# **LOW OIL PRESSURE SWITCH RELOCATION**

## **ICA Supplement**

**MODEL NO: 172**

**SUPPLEMENT NO: ICA-172-79-00001A**  
**SUPPLEMENT DATE: Mmm/DD/2021**

Low Oil Pressure Switch Mounted on Top of the Right-Hand Crank Case at the Aft End  
 Figure 201 (Sheet 1)

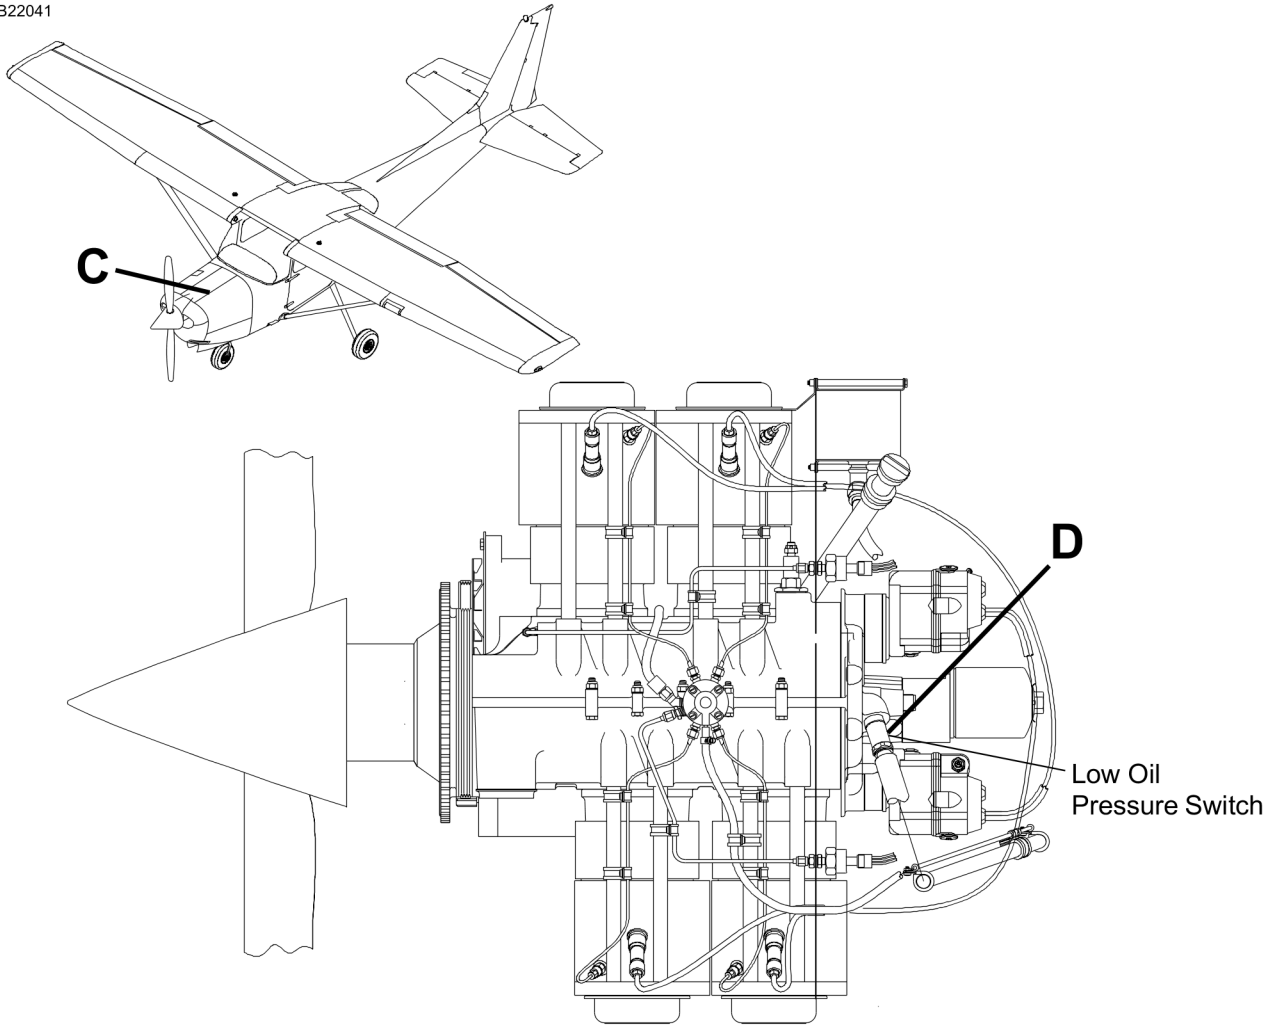
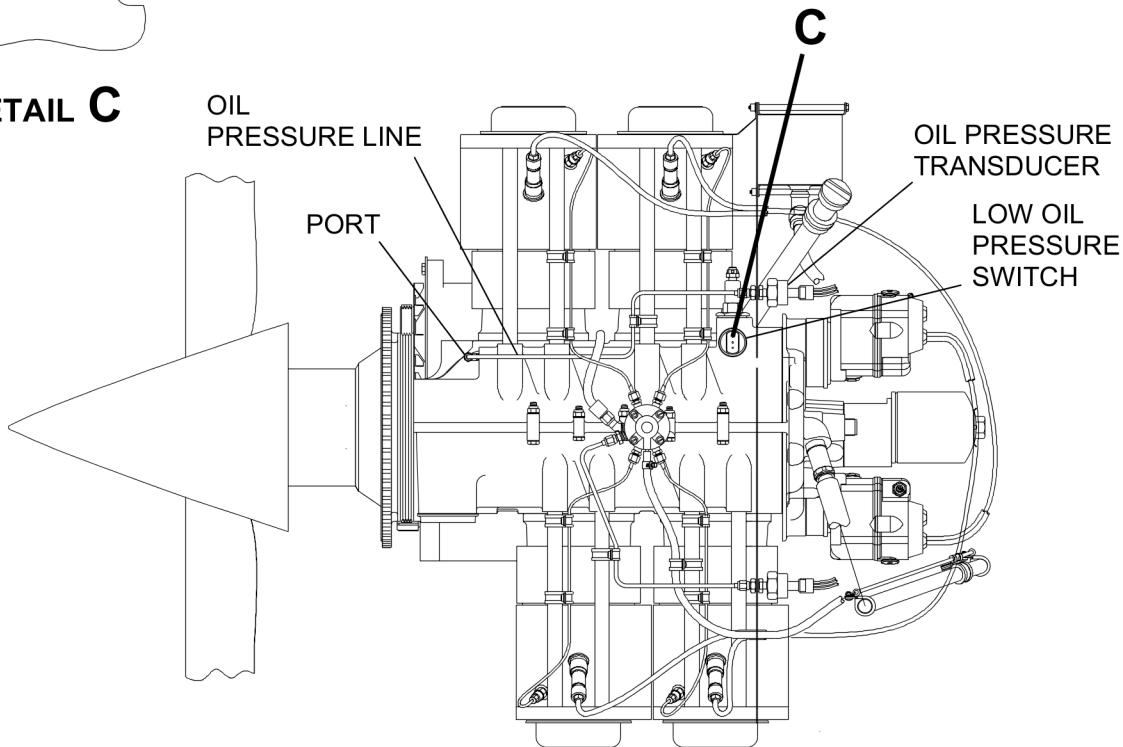
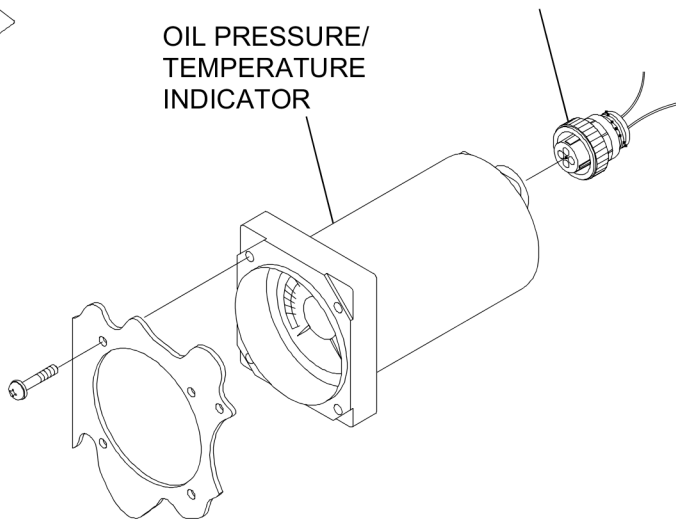
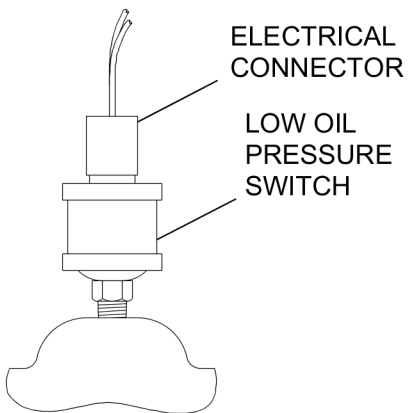
- A. Remove the Low Oil Pressure Switch. (Refer to Figure 201 for switches mounted on the right-hand crankcase and to Figure 202 for switches mounted on the left side of the accessory housing).
- (1) Make sure the electrical power to the airplane is off.
  - (2) Remove the upper cowl. Refer to Chapter 71, Cowling - Maintenance Practices.

B. Install the Low Oil Pressure Switch (Refer to Figure 201 and Figure 202).

- (3) Install switch and tighten by hand.
- (4) Tighten switch approximately 1 to 1 1/2 turns beyond hand tight. Do not tighten the switch to more than 60 in-lbs. Refer to Chapter 20, Torque Data - Maintenance Practices.
- (5) Connect the electrical connector to the switch.
- (6) Install the upper cowl. Refer to Chapter 71, Cowling - Maintenance Practices.
- (7) Make sure the Low Oil Pressure Switch operates correctly.
  - (a) With the engine off, the OIL PRESS annunciator must be ON.
  - (b) With the engine on, the OIL PRESS annunciator must be OFF and the Hobbs hourmeter must be ON.

Low Oil Pressure Switch Mounted Left Side of the Accessory Housing  
 Figure 202 (Sheet 1)

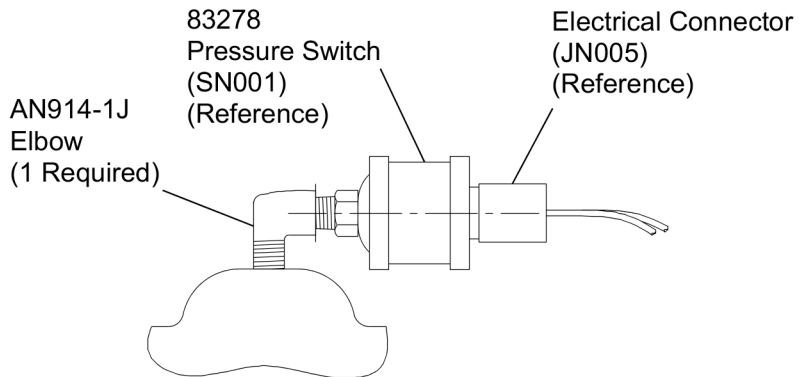
ICA-172-79-00001A	Rev: A	Date: Mmm/DD//2021
ICA Summary	Pages 1-6	
<b>Manuals Affected</b>	<b>Description</b>	<b>Title</b>
Maintenance Manual	5-11-00 pages 1-3	Component Time Limits
<ul style="list-style-type: none"> <li>Updated airplane effectivity verbiage and elbow torque procedure.</li> <li>Airplanes with Oil Pressure Switch installed on the Top RH Crank Case Aft End (Old Location) have a replacement interval of 1,000 hours.</li> <li>Airplanes with Oil Pressure Switch installed on Left Side of the Accessory Housing (New Location) have a replacement interval of 3,000 hours.</li> </ul>		
Maintenance Manual	79-30-00 pages 201-205	Oil Pressure Indicator - Maintenance Practices
<ul style="list-style-type: none"> <li>Revised Low Oil Pressure Switch Removal/Installation procedures to add the new switch installation location. Added removal/installation procedures for the new elbow and Figure 202.</li> </ul>

A. Remove the Low Oil Pressure Switch Elbow (Refer to Figure 202).

B. Install the Low Oil Pressure Switch Elbow (Refer to Figure 202).

- (1) Put U544006 sealant (or equivalent) on the external (male) threads of the elbow.

- (2) Install the elbow until hand tight then rotate the elbow one additional turn, then rotate until the elbow is in an aft direction that provides clearance as not to be in contact with any other components.

**NOTE:** When you tighten the elbow, make sure you point the elbow in a direction that allows space for the installation of the switch.
